DEVELOPMENT ASSESSMENT REPORT	
<b>Application No.</b>	DA/2020/0491
<b>Address</b>	21-21A Edwin Street South CROYDON NSW 2132
<b>Proposal</b>	Alterations and additions to existing dwelling and Torrens title subdivision
<b>Date of Lodgement</b>	30 June 2020
<b>Applicant</b>	Monument Design Partnership
<b>Owner</b>	Mr John L Percy Mr James B Willis
<b>Number of Submissions</b>	Nil
<b>Value of works</b>	\$65,000
<b>Reason for determination at Planning Panel</b>	Clause 4.6 variation exceeds 10%
<b>Main Issues</b>	Subdivision lot size Neighbouring privacy
<b>Recommendation</b>	Approval with Conditions
<b>Attachment A</b>	Recommended conditions of consent
<b>Attachment B</b>	Plans of proposed development
<b>Attachment C</b>	Clause 4.6 Exception to Development Standards

This report is an assessment of the application submitted to Council for alterations and additions to an existing dwelling and Torrens title subdivision at 21-21A Edwin Street South, Croydon.

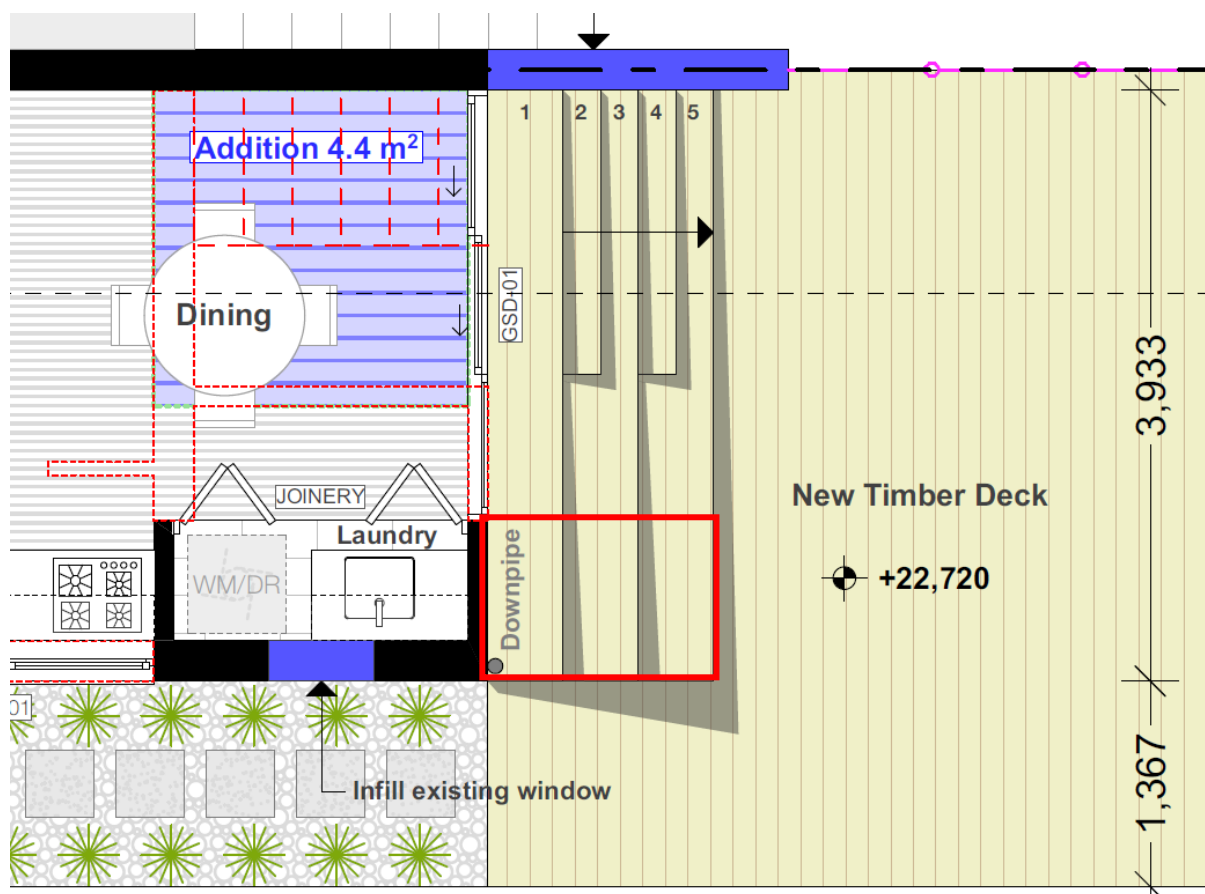
The external staircase structure connecting the living area and the proposed rear deck includes large landings to its southern half. Given its raised nature and proximity to the southern (side) boundary (1.367m), these landings, which do not serve any immediate purpose, may create opportunities for overlooking of the neighbouring property (No. 19A) (see Figure 4 below).

Figure 6: External stairs and landing structure. Red box denotes the area to be deleted. As such, it is a recommended condition of consent that the stairs be setback from southern (side) boundary to be in line with the laundry stacking doors in order to reduce opportunities for overlooking of the neighbouring property.
